# SEATTLE ARENA

1700 FIRST AVENUE SOUTH

DOWNTOWN DESIGN REVIEW BOARD | RECOMMENDATION #3 | 2015 SEPT 1ST

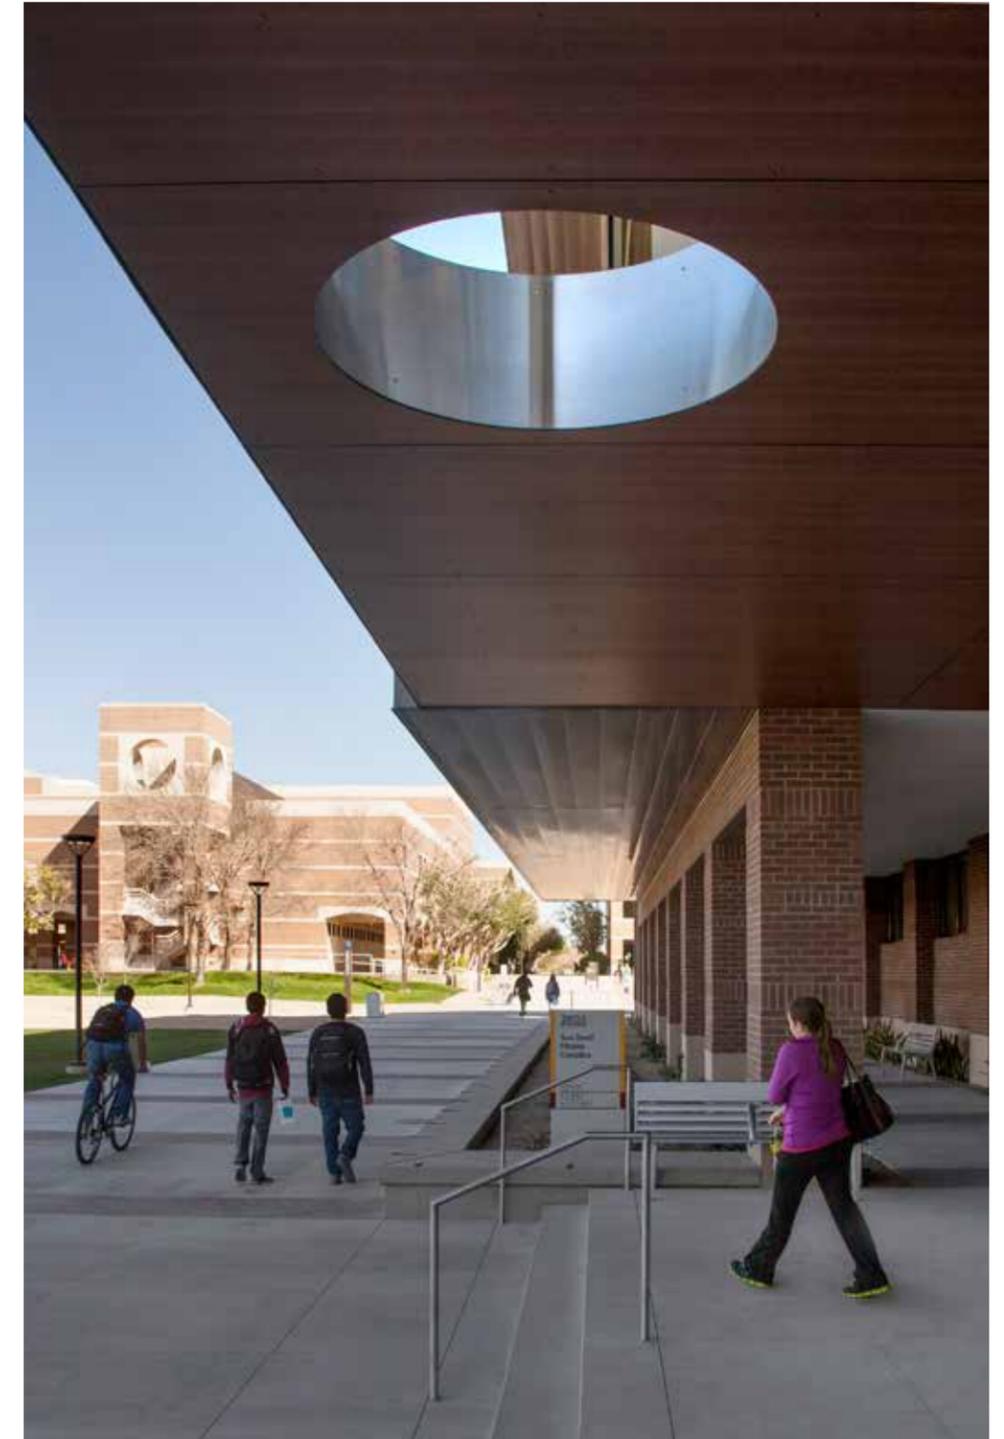
3. Although the warmth and texture is desirable, the detailing, execution and long-term durability of the proposed Trespa synthetic wood was questioned, especially in the multiple soffit, canopy and horizontal conditions proposed. Explore alternatives and/or provide detailed durability tests and confirmation by long-standing example. Also coordinate with comment B-5 above. (B-4)

The example shown on this page is of ASU West Recreation Center. Trespa was used in a similar detail to that being proposed for this project and has held up and performed as expected.

EAST ELEVATION

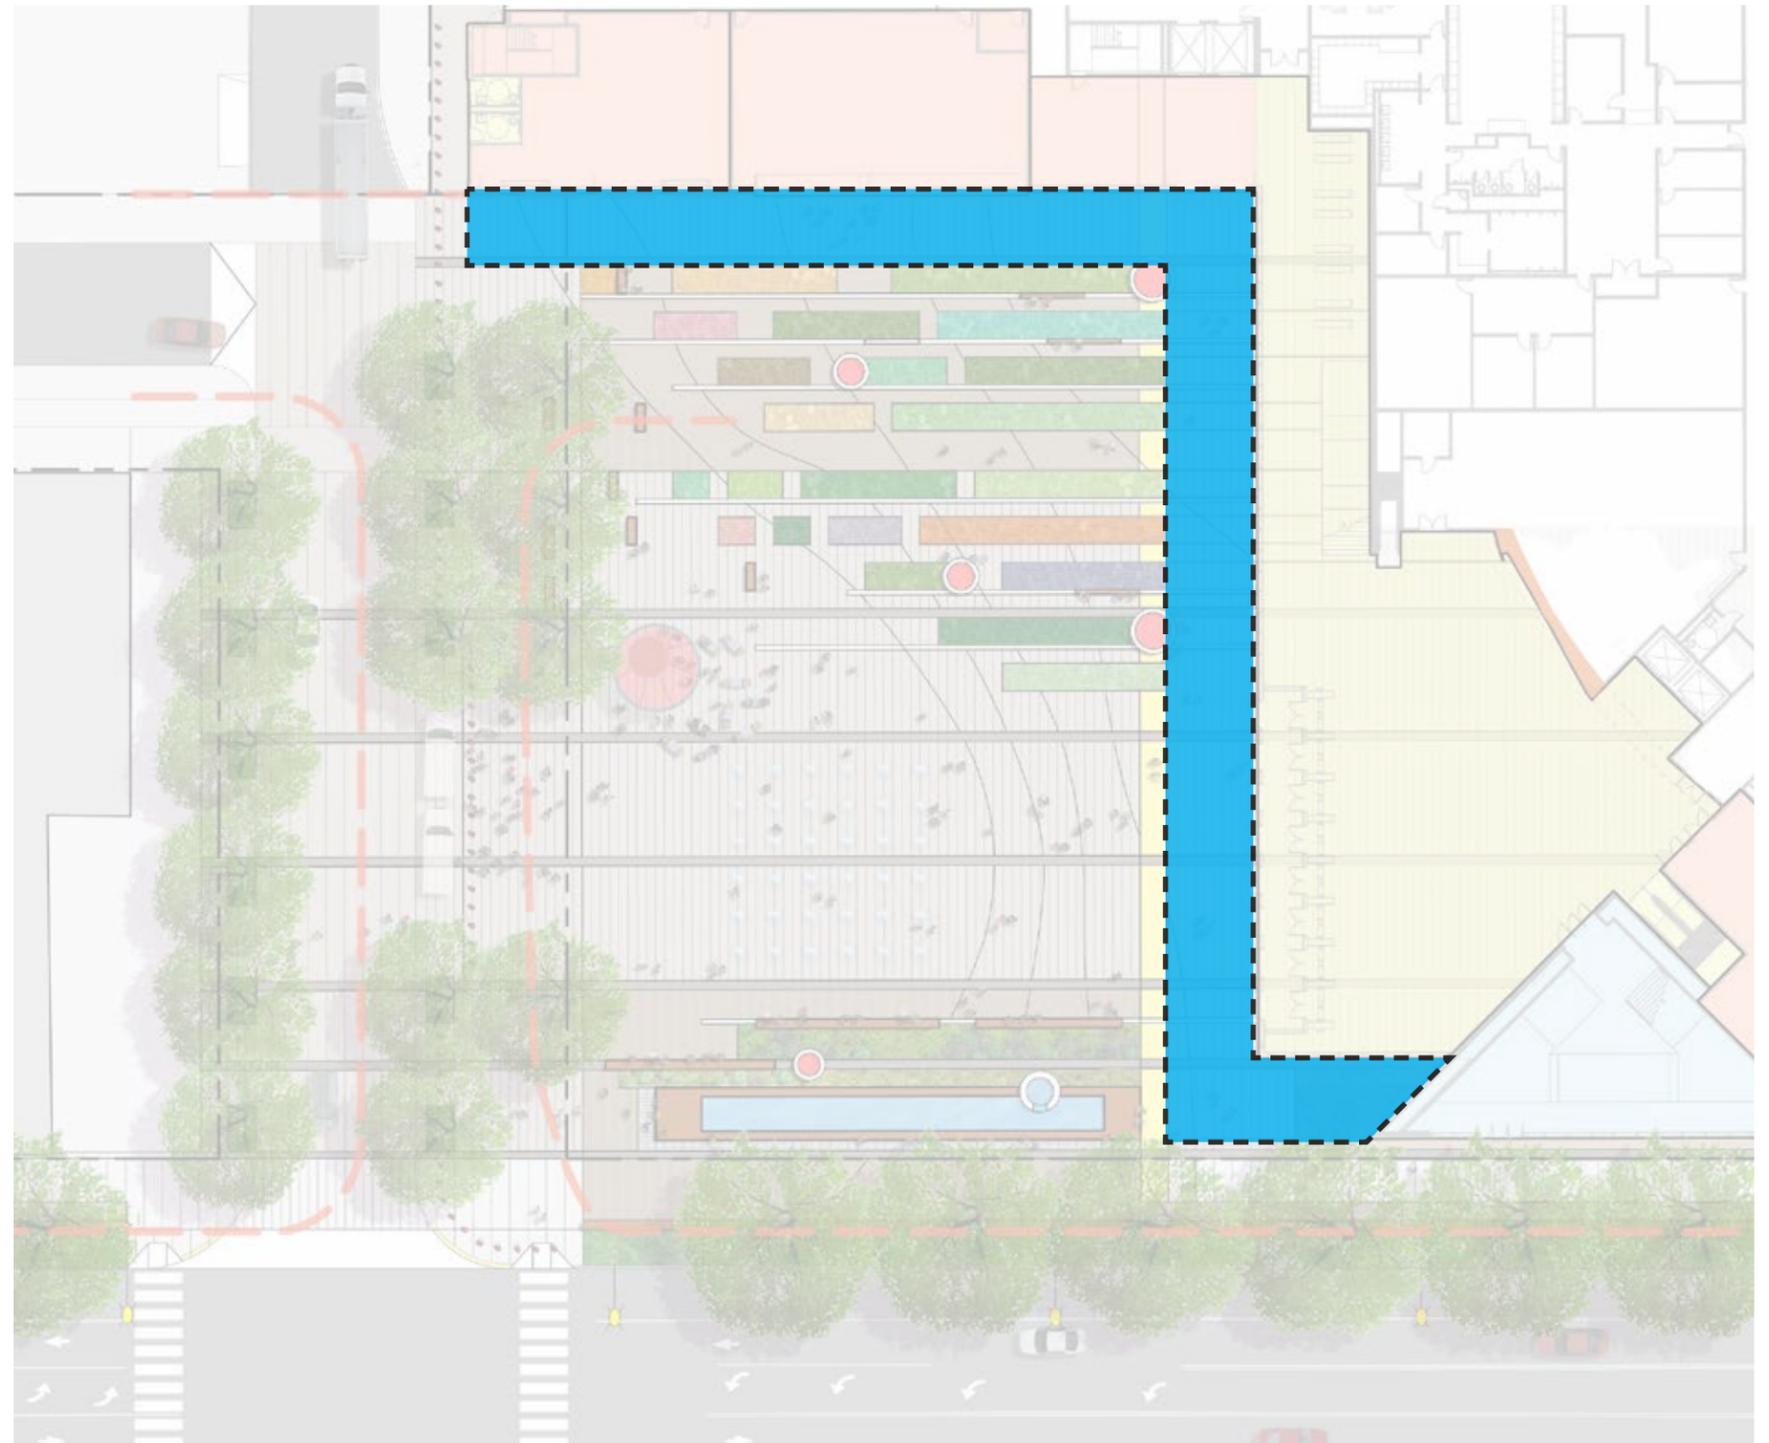
5. The proposed east green screen is an undifferentiated monotonous green wall, 12 ft high x 700 ft long, dependent on plant maintenance and creating CPTED issues. Revise this feature to screen loading areas but provide material changes, transparency, gaps, and/or trees along that length, and consider glazing or more diverse materials on the wall behind it wherever that might be visible. ( C-2, C-6)

Comment noted. Updated elevation modulates with building massing and plan to create a facade that scales appropriately.

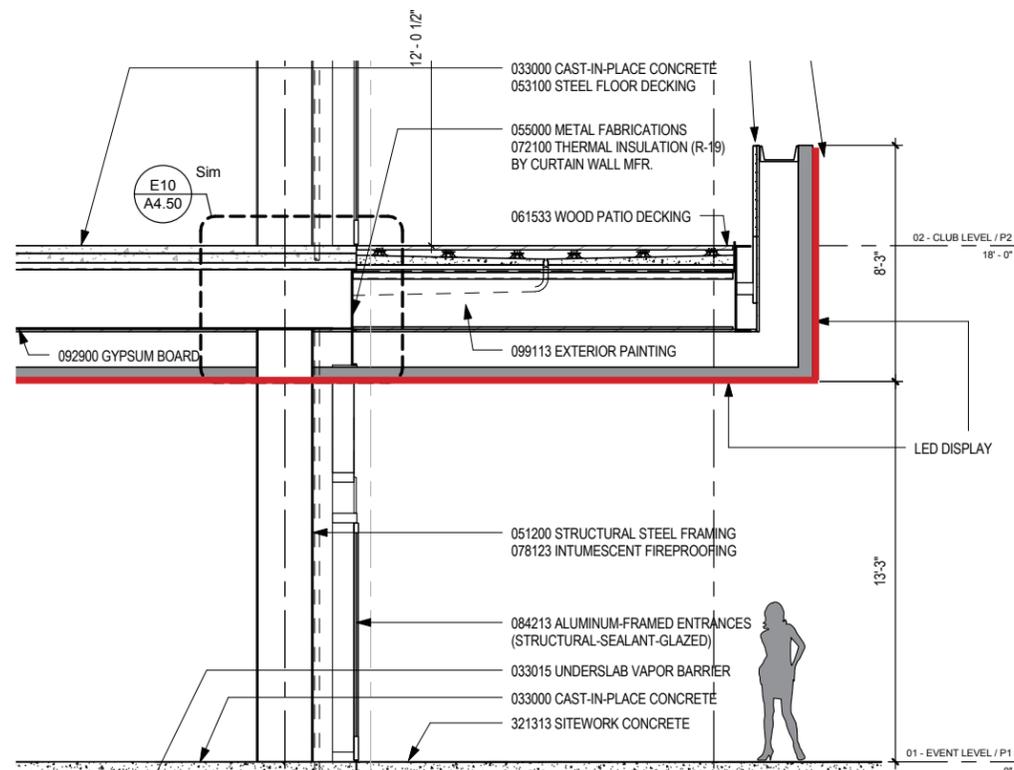
2. Detailed close-in perspectives (pg 100 without obscuring trees) and cross sections with dimensions of the approximately 12 x 80 ft northwest signage portal. Also provide alternative lighting/message examples. (C-4, D-4)

Comment noted. (see graphic this page)

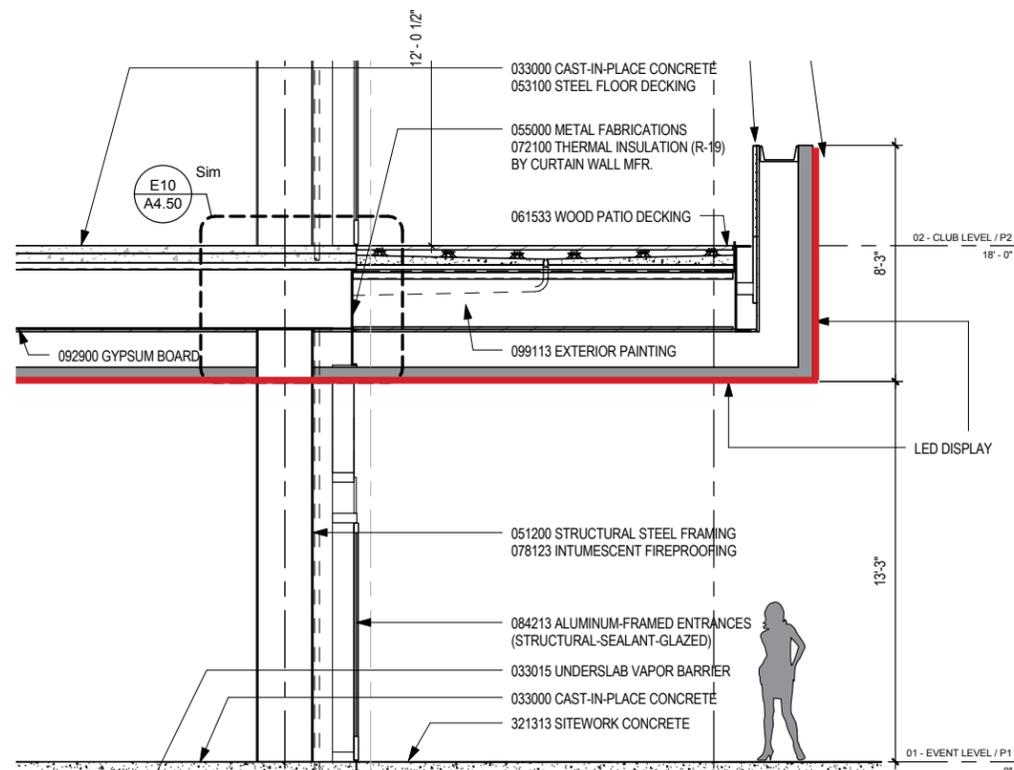
2. Detailed close-in perspectives (pg 100 without obscuring trees) and cross sections with dimensions of the approximately 12 x 80 ft northwest signage portal. Also provide alternative lighting/message examples. (C-4, D-4)

Comment noted. (see graphic this page)
